Access Compliance Report

Public Rights-of-Way

Intersection ID: 11148	Main Street: MATHESON_AV	Cross Street: VIRGINIA_AV	Location: E
ADA ID: B4F20DB7F71D	Ramp Type: PerpDiag	Initial Pass/Fail: Fail	Overall Compliance: No
Severity Score: 8.75			
Codes/Mitigation Info/Possible Solution		Field Measurements/Component Compliance

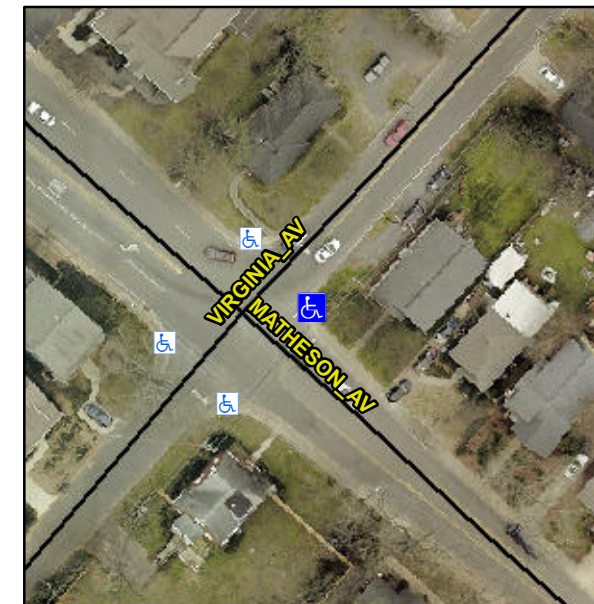
Not Found, R304.5.1

Compliance	Description	Data	Compliance	Description	Data
N/A	Ramp Length (in)	59.5	Yes	Ramp Slope (%)	5.4
No	Ramp Width (in)	39.5	Yes	Ramp XSlope (%)	1.0
N/A	Flare Type LT	N/A	N/A	Flare Type RT	N/A
N/A	Flare Slope LT (%)	N/A	N/A	Flare Slope RT (%)	N/A
N/A	Flare Traversable LT?	N/A	N/A	Flare Traversable RT?	N/A
N/A	Landing Length (in)	N/A	N/A	DWS Provided?	N/A
N/A	Landing Width (in)	N/A	N/A	DWS Contrast?	N/A
N/A	Landing Slope (%)	N/A	N/A	DWS Length (in)	N/A
N/A	Landing X Slope (%)	N/A	N/A	DWS Full Width?	N/A
N/A	Landing Curb? (Y/N)	N/A	N/A	DWS Offset (in)	N/A
N/A	Shared Landing?	N/A			
N/A	Gutter Ponding?	N/A	N/A	Gutter Slope (%)	N/A
N/A	Gutter Lip Ht (in)	N/A	N/A	Gutter X Slope (%)	N/A
N/A	Painted X Walk1?	No	N/A	Painted X Walk2?	No
	X Walk 1 Direction	To NW		X Walk 2 Direction	To SW
N/A	X Walk 1 Width (in)	N/A	N/A	X Walk 2 Width (in)	N/A
	X Walk 1 Slope (%)	4.5		X Walk 2 Slope (%)	1.9
	X Walk 1 X Slope (%)	1.3		X Walk 2 X Slope (%)	1.6

N/A	Ramp inside XWalk1?	N/A	N/A	Ramp inside XWalk2?	N/A
	Road Slope (%)	1.6	N/A	Clear Space?	N/A
	Road X Slope (%)	5.9	N/A	Clear Space to XWalk (in)	N/A
N/A	Any Obstructions?	N/A	N/A	Storm Grate/Utility Hazard?	N/A
	Obstruction Type			Storm Grate/Utility Type	
		N/A			N/A
			Yes	Surface Condition? (G/P)	Good

Remove & Replace Curb Ramp With Two New Directional Ramps or Equivalent.
